Title of Change:	Revision of Case Outline 507BA
Effective date:	05 Jul 2024
Contact information:	Contact your local onsemi Sales Office or Sarmila.Kamalanathan@onsemi.com
Type of notification:	This Product Bulletin is for notification purposes only. onsemi will proceed with implementation of this change upon publication of this Product Bulletin.
Change Category:	Assembly Change
Change Sub-Category(s):	Datasheet/Product Doc change

MECHANICAL CASE OUTLINE PACKAGE DIMENSIONS

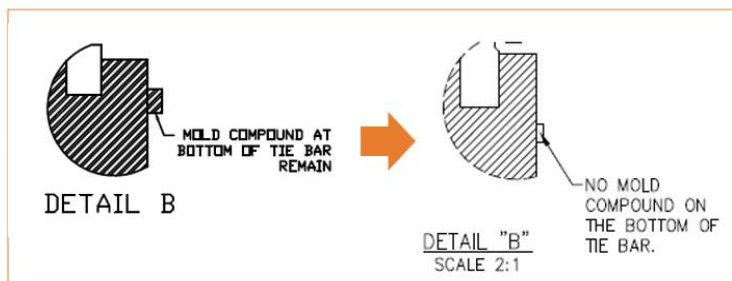
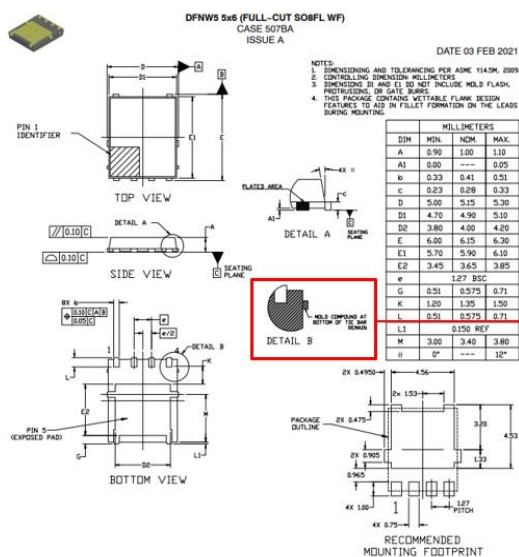
This Product Bulletin is to advise customers of a change to detail B in case outline from “Mold compound at the bottom of tie bar remains” to “No mold compound at the bottom of the tie bar” for case 507BA. No change to solder footprint is required. There is no material, dimension or manufacturing change.
